V2500-A1/A5/D5 SERIES PROPULSION SYSTEMS SERVICE BULLETIN

This document transmits Revision 1 to Service Bulletin EV2500-79-0077

V2500-ENG-79-0077

MODIFICATION SERVICE BULLETIN – ENGINE – OIL INTRODUCTION OF A NEW OIL SCAVENGE PUMP
WITH IMPROVED CASING, SPACERS AND COVERS

Oil scavenge pump
Fig 1 sheet 1

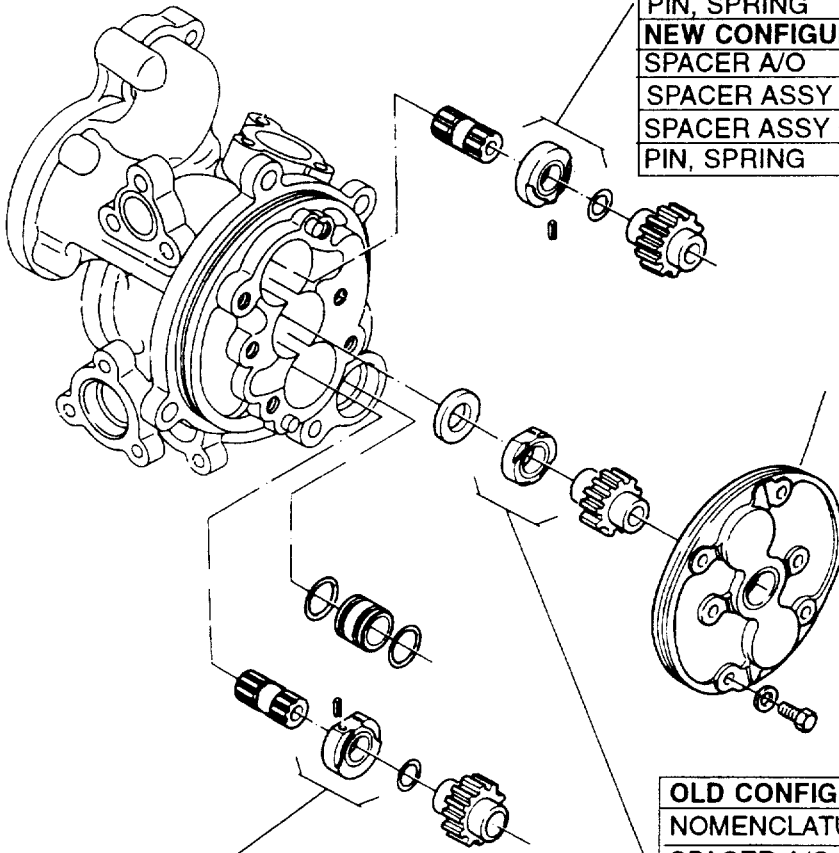
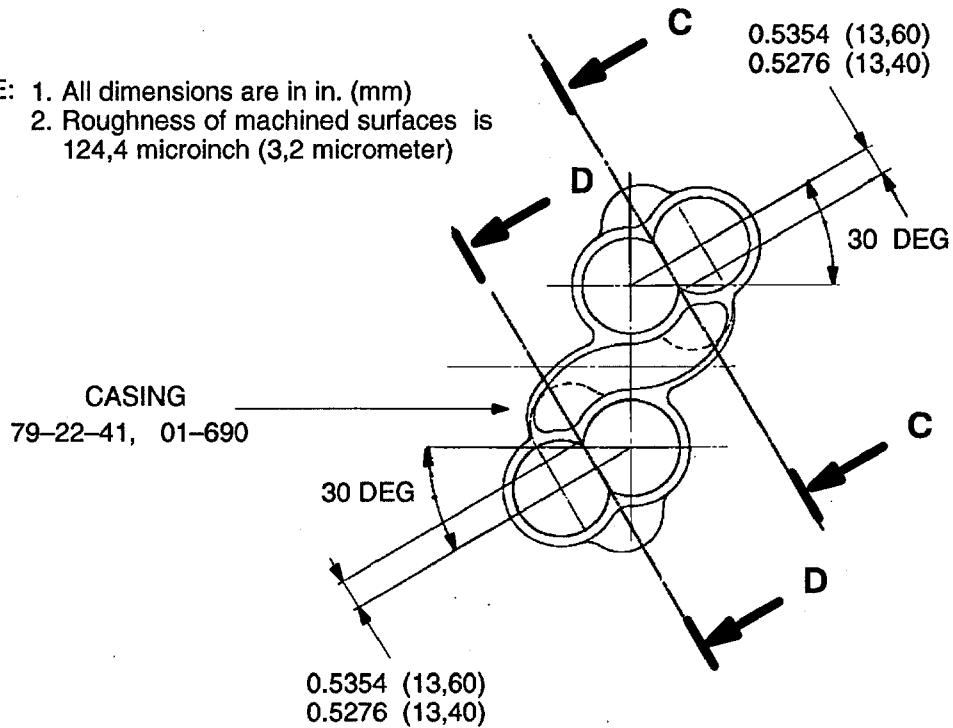
- (a) Introduce an upgraded oil scavenge pump.
- (b) Introduce new covers with pockets in correspondence of the gear mesh zone.
- (c) Introduce new spacers with foolproof installation feature and without hard coating treatment.
- (d) Add two new Fig-Item positions for spacers. refer to Figure 1.
- (e) Casing and covers can be reworked. Refer to Section 3.

OLD CONFIGURATION		
NOMENCLATURE	FIG-ITEM	P/N
SPACER A/O	01-270	4B7321
SPACER ASSY CLASS	01-271	4B7321CL01
SPACER ASSY CLASS	01-272	4B7321CL02
PIN, SPRING	01-277	MS171462
NEW CONFIGURATION		
SPACER A/O	01-270	4B7344
SPACER ASSY CLASS	01-271	4B7344CL01
SPACER ASSY CLASS	01-272	4B7344CL02
PIN, SPRING	01-277	MS171462

OLD CONFIGURATION		
NOMENCLATURE	FIG-ITEM	P/N
SPACER A/O	01-270	4B7321
SPACER ASSY CLASS	01-271	4B7321CL01
SPACER ASSY CLASS	01-272	4B7321CL02
PIN, SPRING	01-277	MS171462
NEW CONFIGURATION		
SPACER A/O	01-530	4B7345
SPACER ASSY CLASS	01-531	4B7345CL01
SPACER ASSY CLASS	01-532	4B7345CL02
PIN, SPRING	01-537	MS171462

OLD CONFIGURATION		
NOMENCLATURE	FIG-ITEM	P/N
SPACER A/O	01-200	4B7320
SPACER ASSY CLASS	01-201	4B7320CL01
SPACER ASSY CLASS	01-202	4B7320CL02
PIN, SPRING	01-207	MS171462
NEW CONFIGURATION		
SPACER A/O	01-200	4B7342
SPACER ASSY CLASS	01-201	4B7342CL01
SPACER ASSY CLASS	01-202	4B7342CL02
PIN, SPRING	01-207	MS171462

OLD CONFIGURATION		
NOMENCLATURE	FIG-ITEM	P/N
SPACER A/O	01-200	4B7320
SPACER ASSY CLASS	01-201	4B7320CL01
SPACER ASSY CLASS	01-202	4B7320CL02
PIN, SPRING	01-207	MS171462
NEW CONFIGURATION		
SPACER A/O	01-211	4B7343
SPACER ASSY CLASS	01-213	4B7343CL01
SPACER ASSY CLASS	01-215	4B7343CL02
PIN, SPRING	01-219	MS171462

Machine the casing
Fig 2

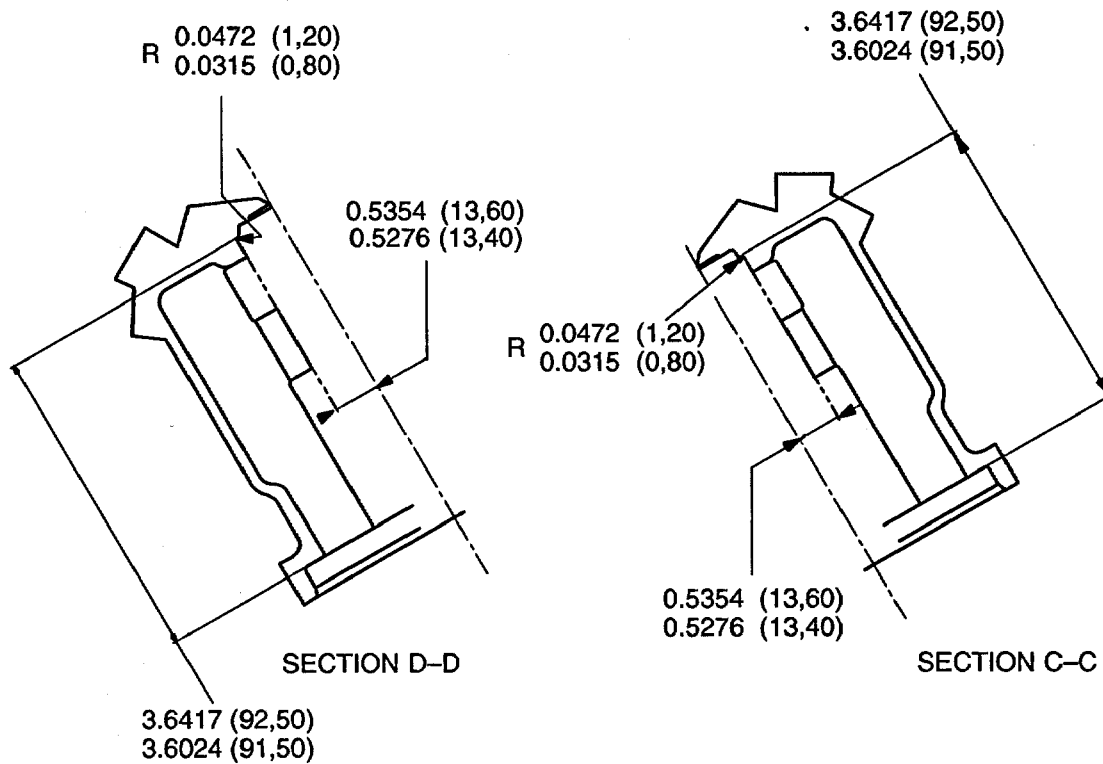
PROCEDURE	RELATED DATA
(a) Machine the casing	Refer to Figure 2
(b) Do an inspection of the casing	See reference (4), TASK 72-23-05-230-501. No cracks permitted.
(c) Apply the chromate conversion coating to the machined surfaces.	See reference (4), TASK 70-38-02-300-503.
(d) Cancel the old part number and identify the part with the new part number.	Old part number 4B7107 New part number 4B7349 See references (4) TASK 70-09-00-400-501. Use vibro-engraving equipment.

NOTE: 1. All dimensions are in in. (mm)
2. Roughness of machined surfaces is 124,4 microinch (3,2 micrometer)

Machine the cover (01-050)
Fig 3

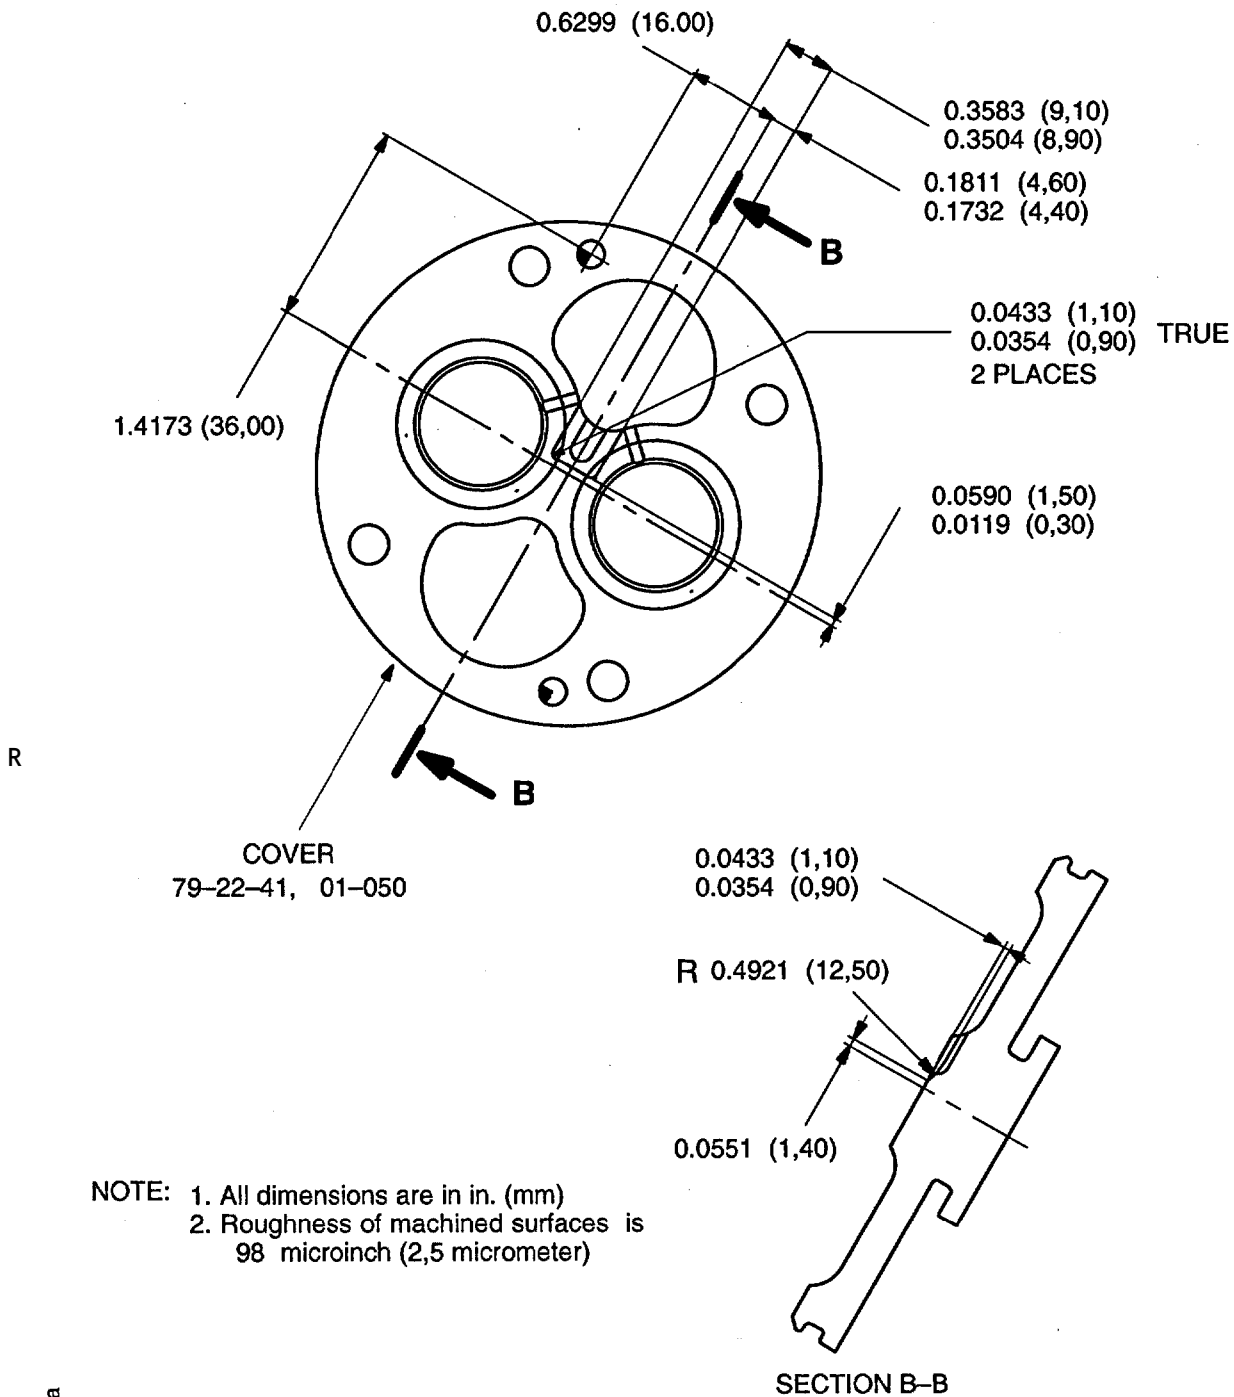
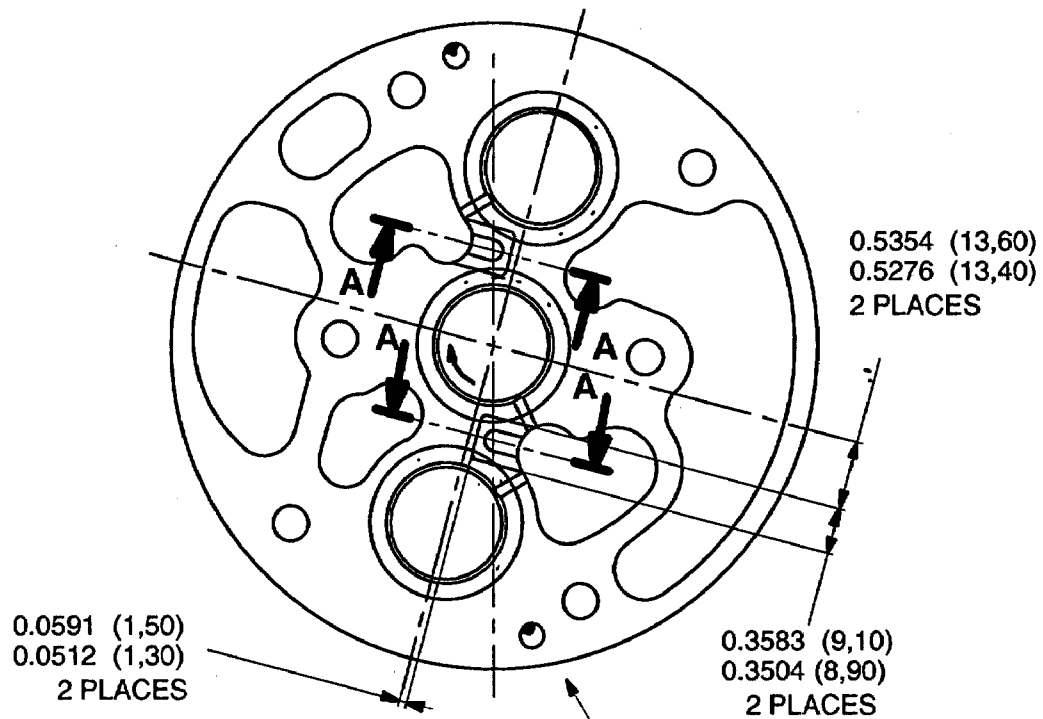
(a) Machine the cover	Refer to Figure 3.
-----------------------	--------------------

Machine the cover (01-330)
Fig 4

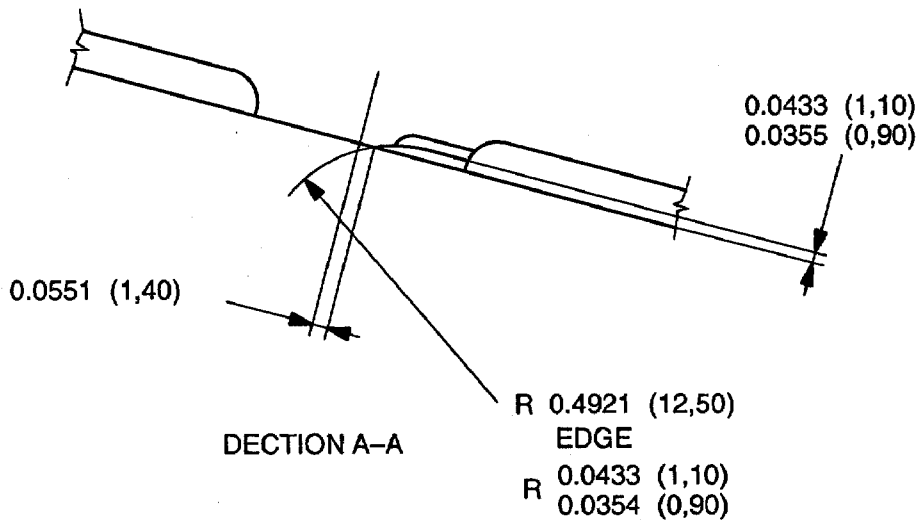
| (a) Machine the cover | Refer to Figure 4 |

NOTE: 1. All dimensions are in in. (mm)
2. Roughness of machined surfaces is
98 microinch (2,5 micrometer)
